CITY PLAN COMMISSION STAFF REPORT

Project Name Promise Place

Docket #6/ Case # Request
.1 - CD-CPC-2022-00084 – Area Plan Amendment.
.2 – CD-CPC-2022-00086 – Rezoning with plan

Plan Conditions

KEYNOTE LEGEND

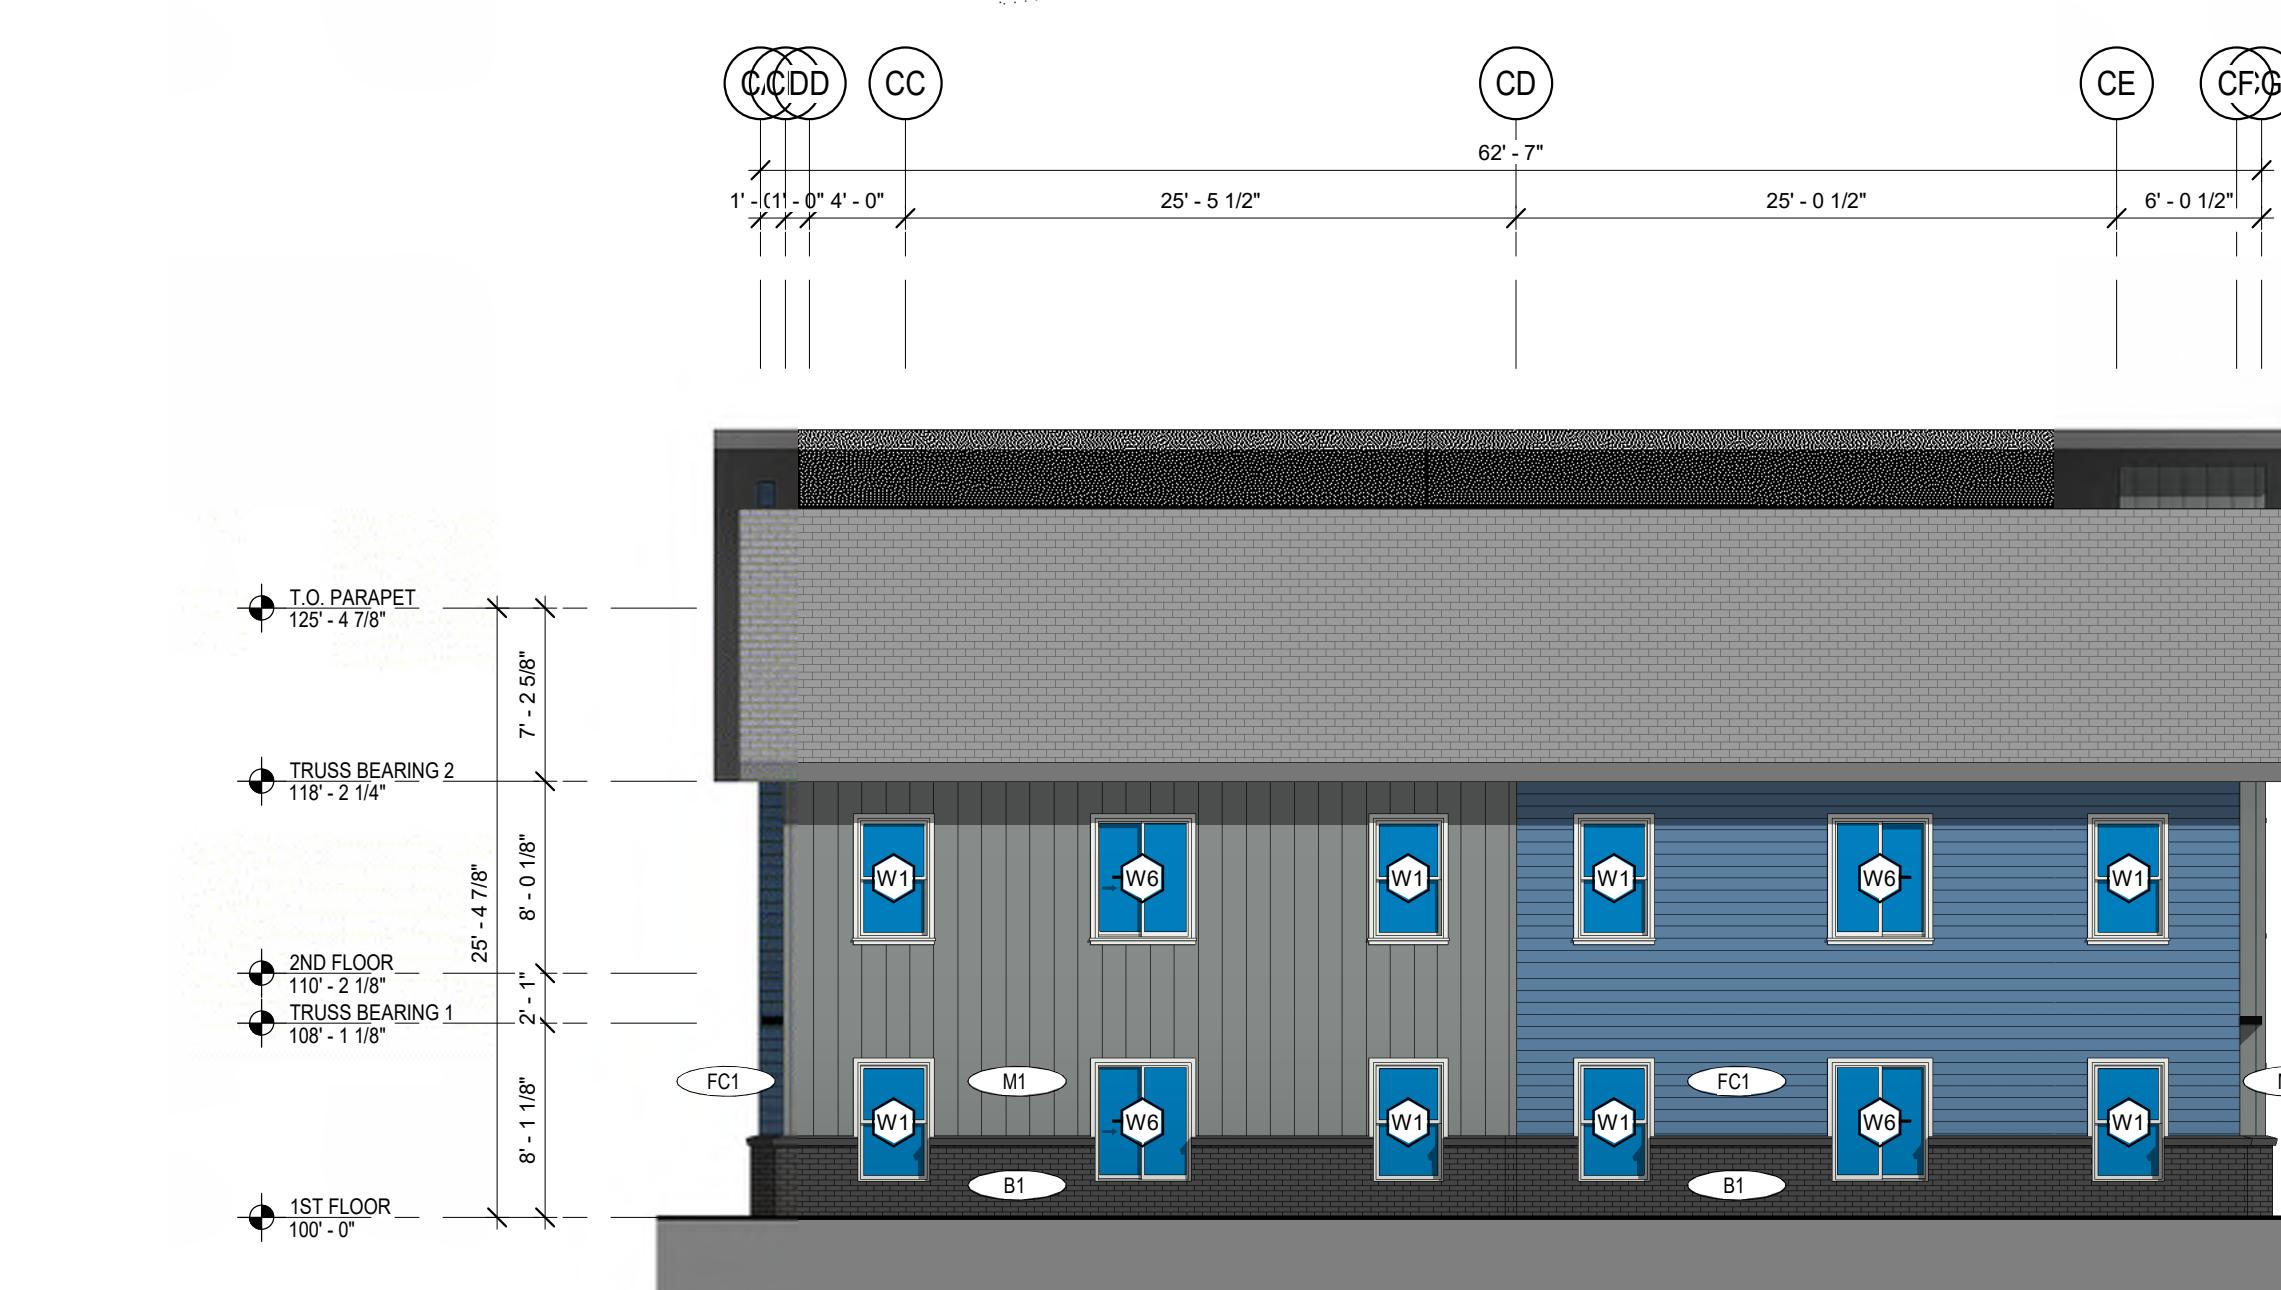
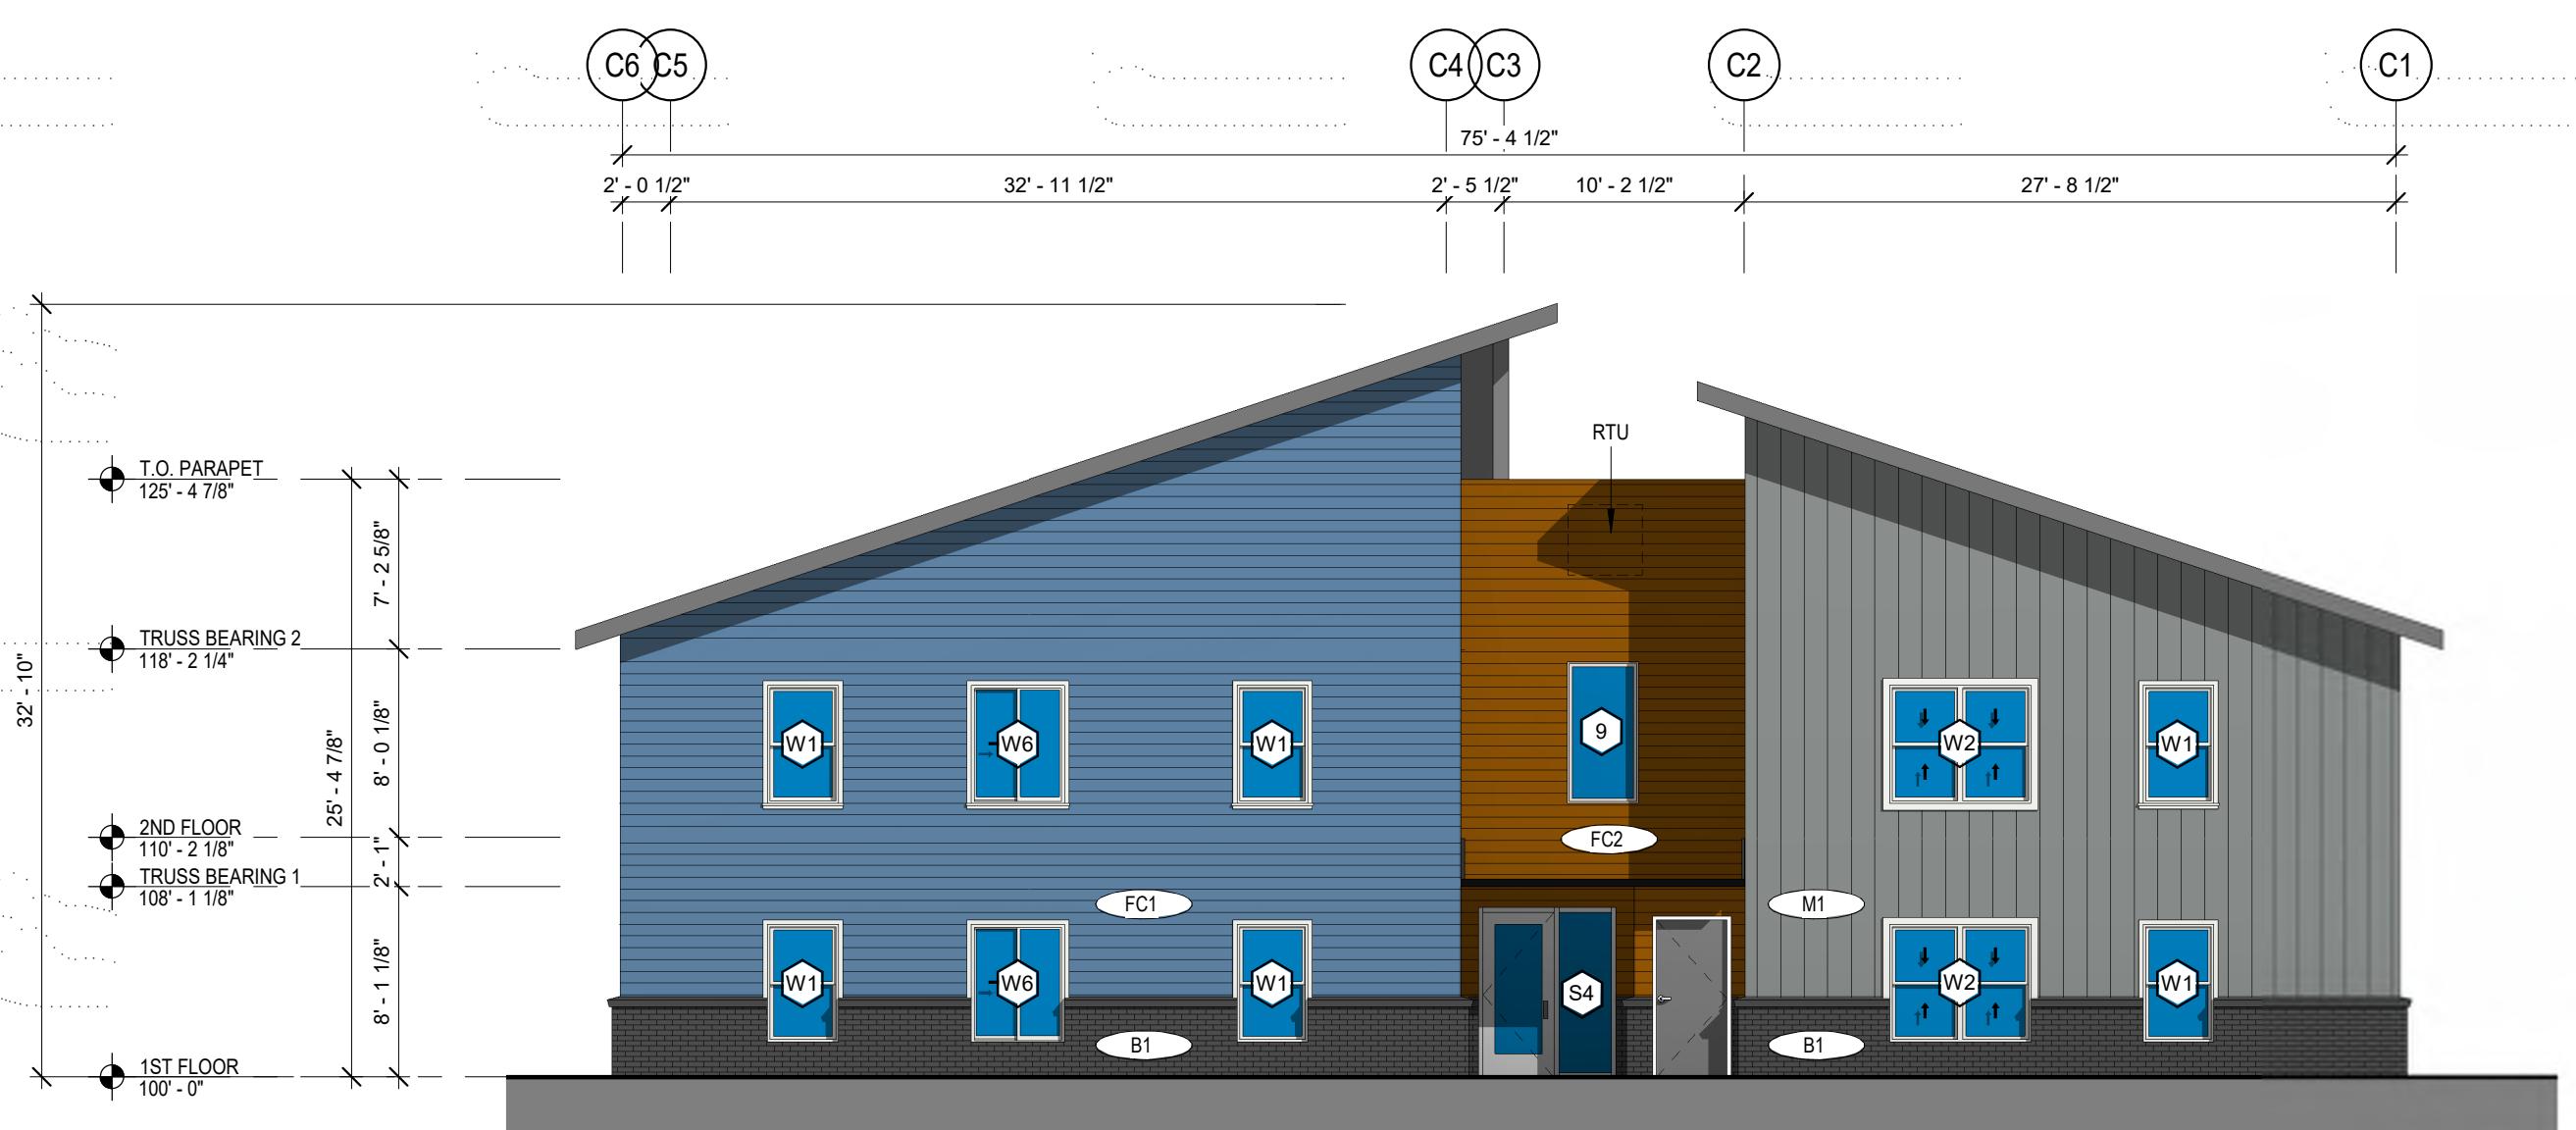
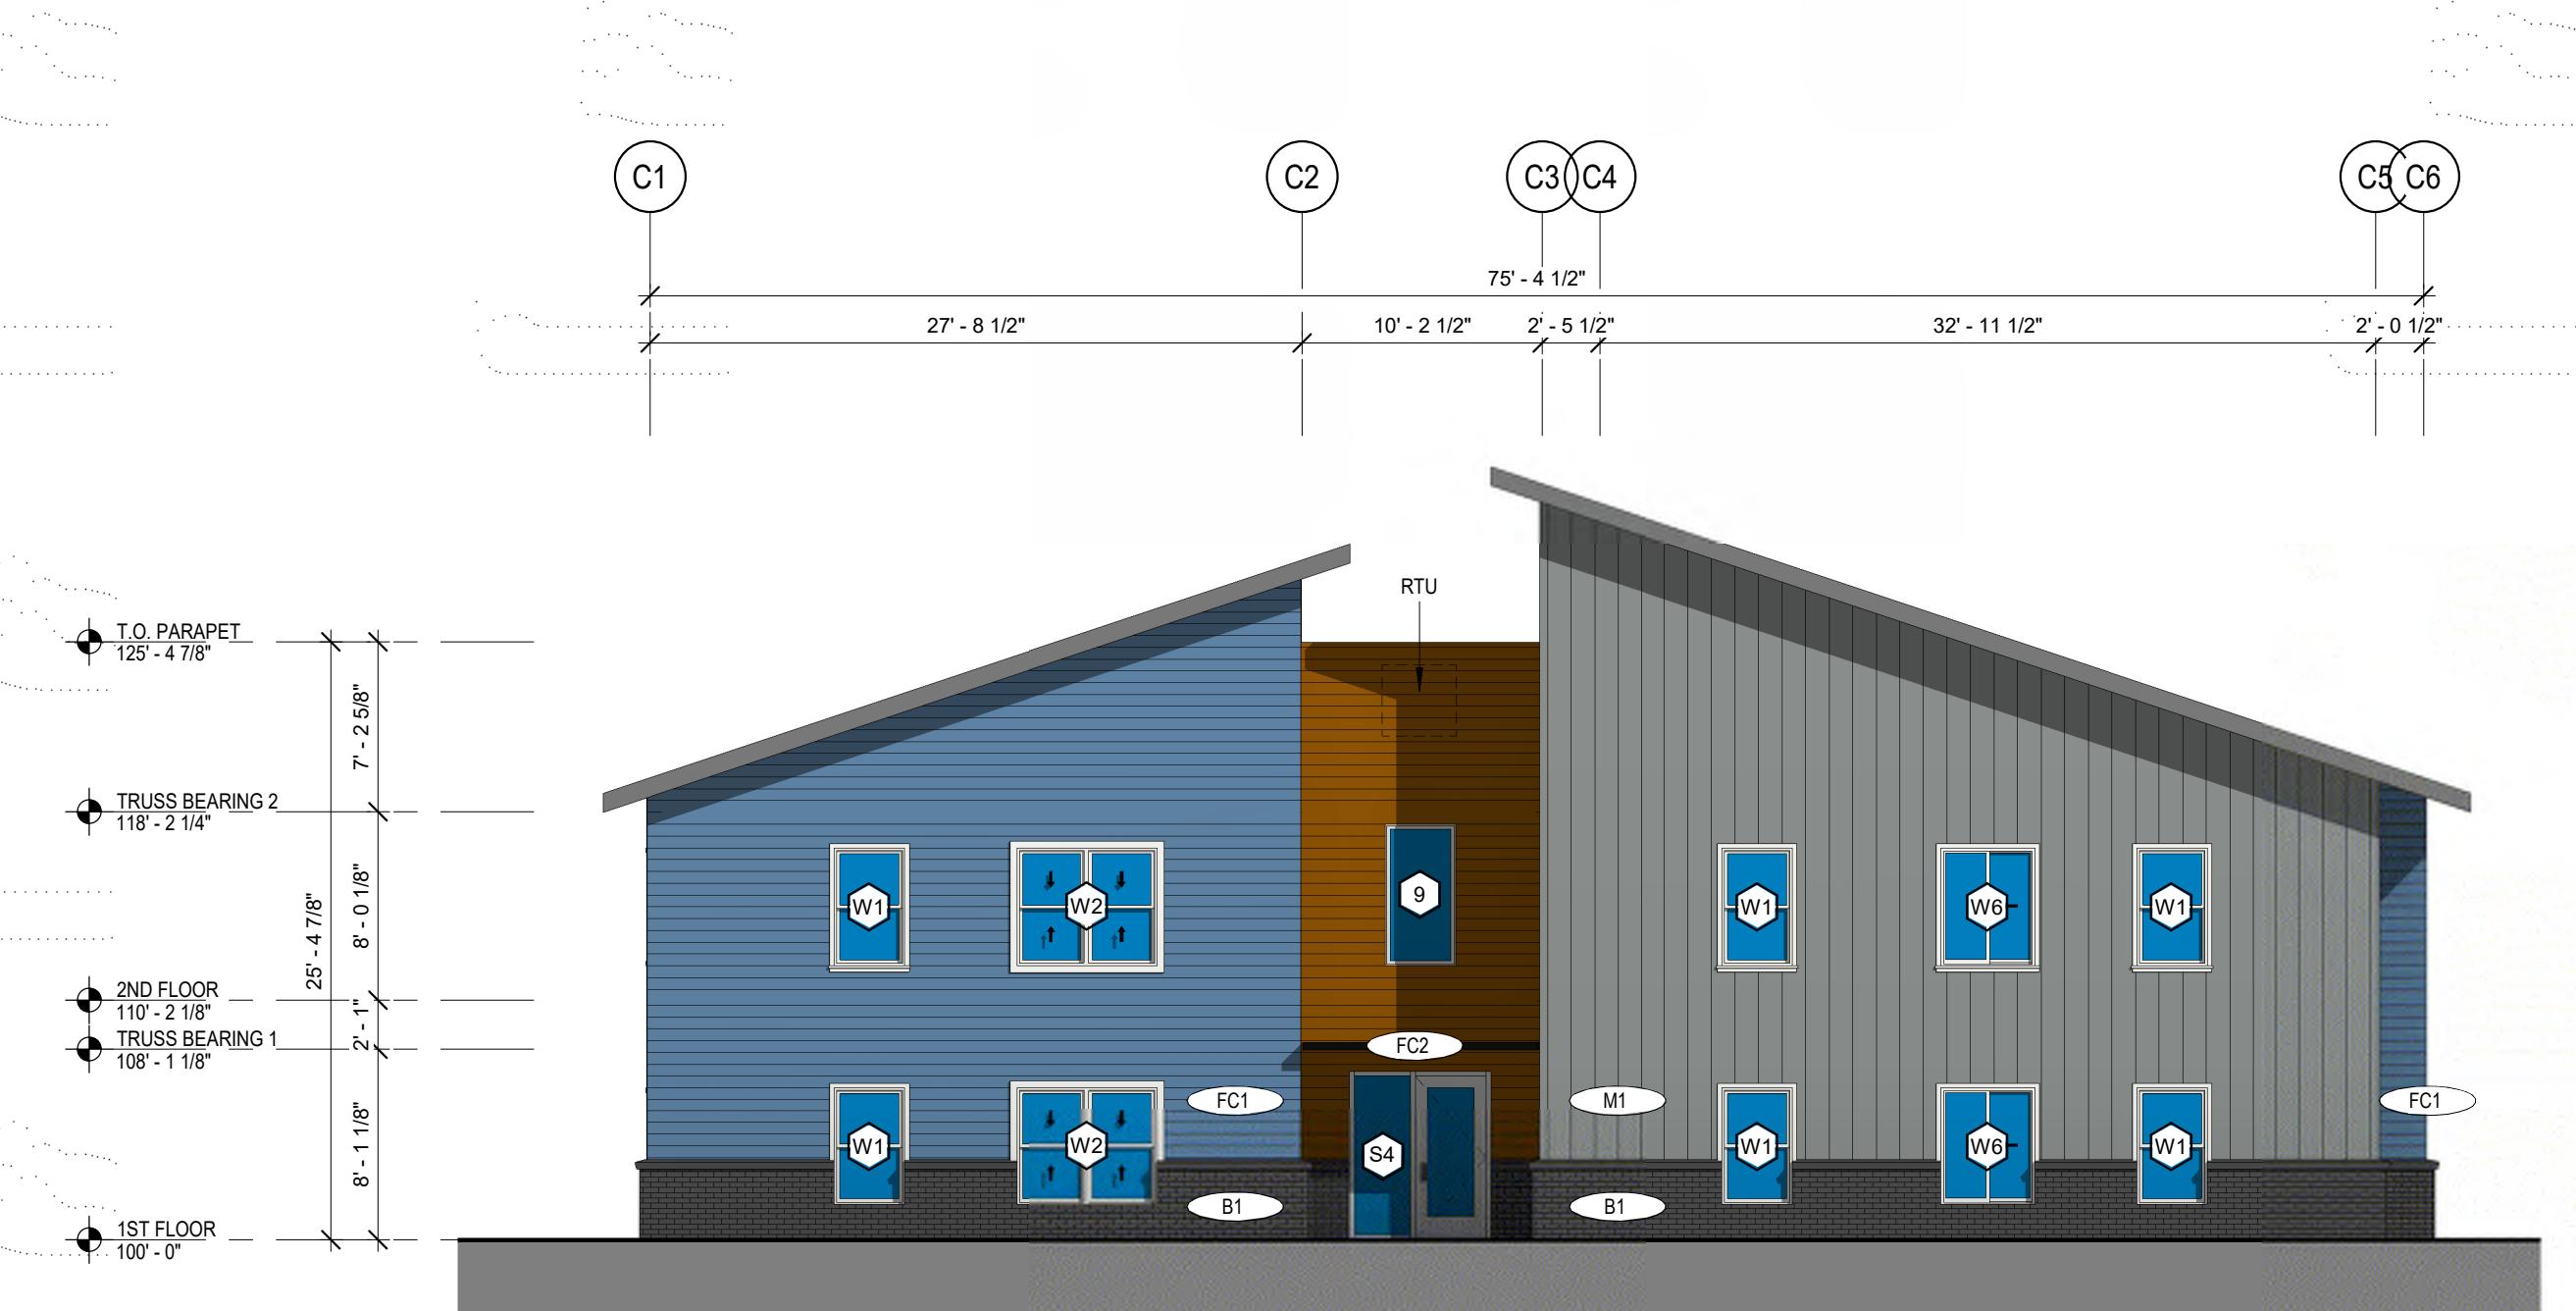
Staff was concerned about the initial building elevation that shows blank walls that face the public street or public sidewalk. Staff recommended that the building elevations be revised to provide a primary entrance for each building facing and directly accessible from the public street and a secondary entrance for each building facing the parking courtyard. Staff also recommended that the pedestrian circulation system that connects residential entrances to adjacent public right-of-way (sidewalks) and to parking area. Other comments require that the developer create open space for amenities for the residents. The applicant has met with staff and submitted the accompanying revised plan addressing most of the attached corrections and conditions. As a result, the corrections will be revised prior to ordinance request.

5. That the developer continue to work with staff to ensure that the building elevations and design meet the requirement of the Zoning and Development Code and the recommendations of the design guidelines of the the Heart of the City Area Plan prior to City Council action.
6. The developer shall submit an affidavit, completed by a landscape architect licensed in the State of Missouri, verifying that all landscaping required of the approved plan has been installed in accordance with the plan and is healthy prior to Certificate of Occupancy.
7. That all signage shall conform to 88-445 and shall require a sign permit prior to installation.
